DNR File No. DC-0123

Subject: Amendment to the *Dane County Water Quality Plan*, Revising the Oregon Urban Service Area Boundary and Environmental Corridors in the Village of Oregon.

Map 1
 Amendment to the
 Central Urban Service
 Area in the Village of
 Oregon

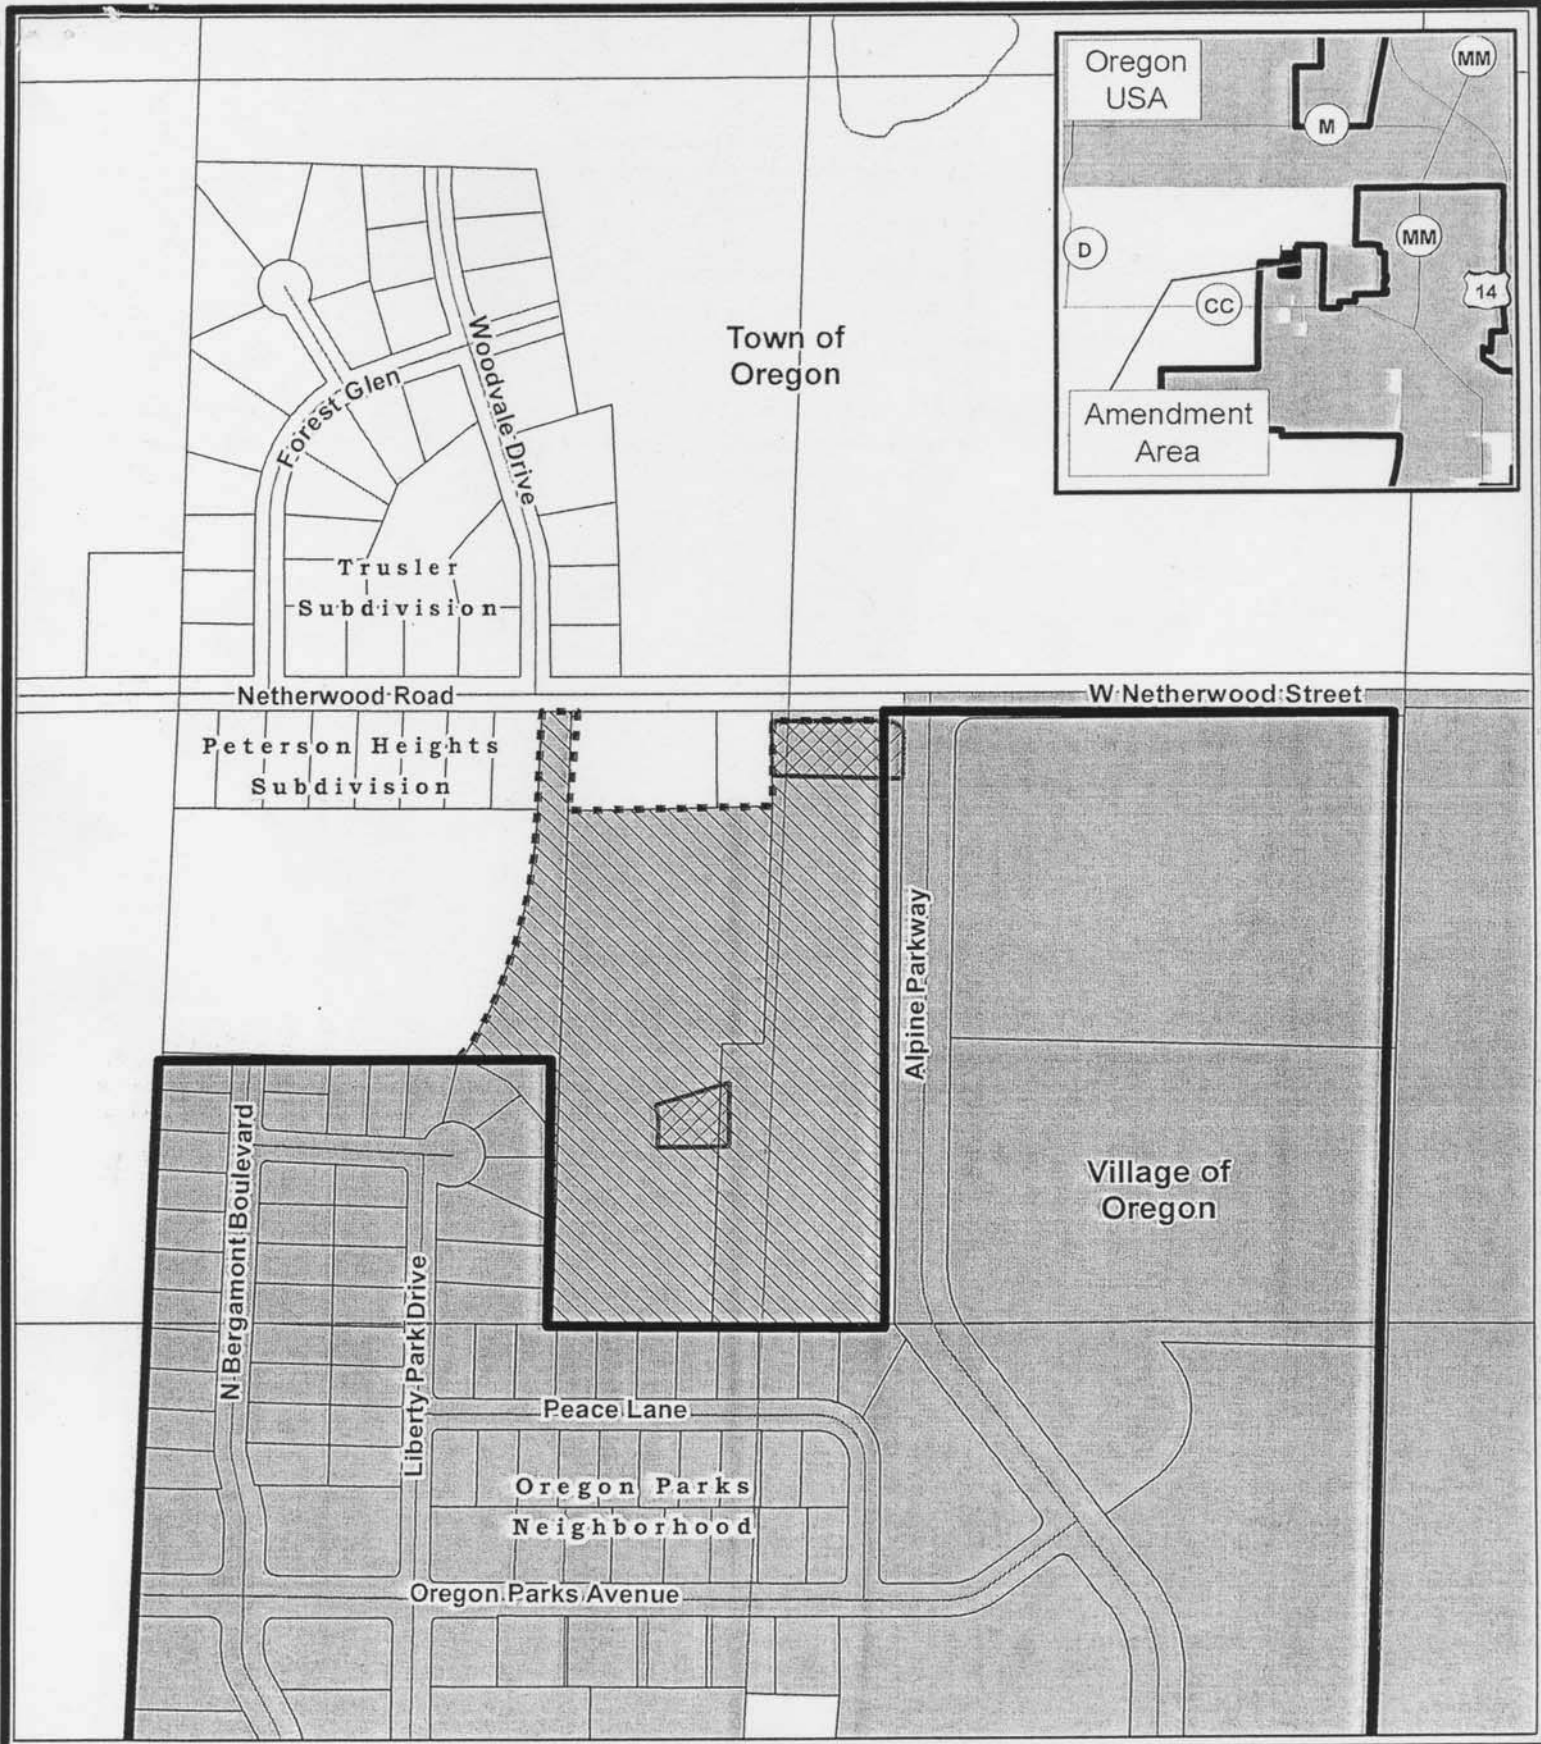
We have completed our review of the subject amendment request that was submitted to the Department on July 7, 2008 by the Capital Area Regional Planning Commission. The Department hereby approves this amendment request which adds 20.2 acres to the Oregon Urban Service Area, including 1.5 acres of existing development and 1.2 acres of environmental corridor. The amendment also proposes designating 0.1 acres within the existing urban service area as environmental corridor, resulting in a net addition of 17.4 developable acres to the Oregon Urban Service Area. The amendment area is contiguous to the northwest side of the existing urban service area and is located south of Netherwood Road and west of N. Alpine Parkway. (See attached Map 1.)

This Department approval is subject to the condition that the Village of Oregon comply with all the conditions stated in Resolution CARPC No. 2008-12 regarding a stormwater management plan, in addition to the following conditions:

1. Require a tree protection plan for the amendment area by a certified arborist, and require its implementation as part of the plat approval and development.
2. Prohibit disturbance of areas with slopes over 12%.
3. Ensure stringent enforcement of construction erosion control practices in the amendment area.
